**ANGEL PLACE  
LEVEL 8, 123 PITT STREET  
SYDNEY NSW 2000**

8<sup>th</sup> April 2019

## **SUBMISSION TO IPC - WALLACIA MEMORIAL PARK**

Figure 1 – Regional Context – Wallacia Memorial Park

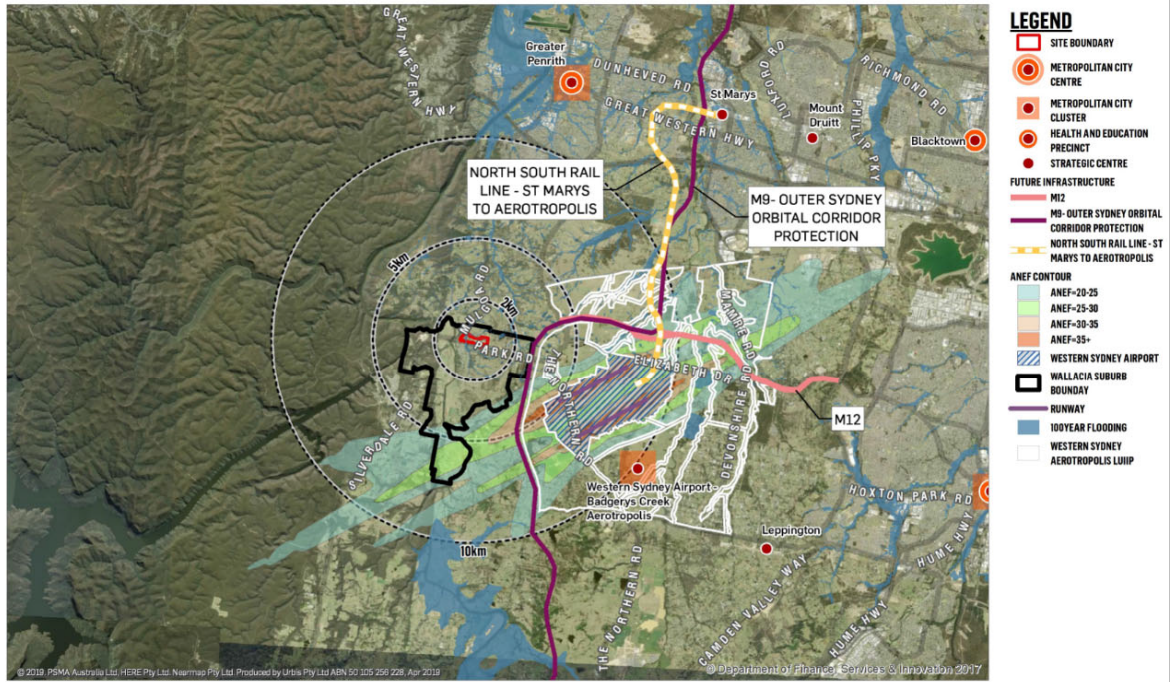
The local character and amenity of the local area in our opinion will change significantly over time due to the proximity (less than 5km) to Western Sydney Airport and urban development associated with its establishment, including the Aerotropolis. As shown in the Figure 1 below, the site is also approximately 3km from the planned M9 outer orbital corridor (which intersects Park Road); close to noise contours associated with the Airport. Notably, the M9 corridor also forms the boundary of the Government's Land Use and Infrastructure Plan for the wider Aerotropolis Structure Plan.
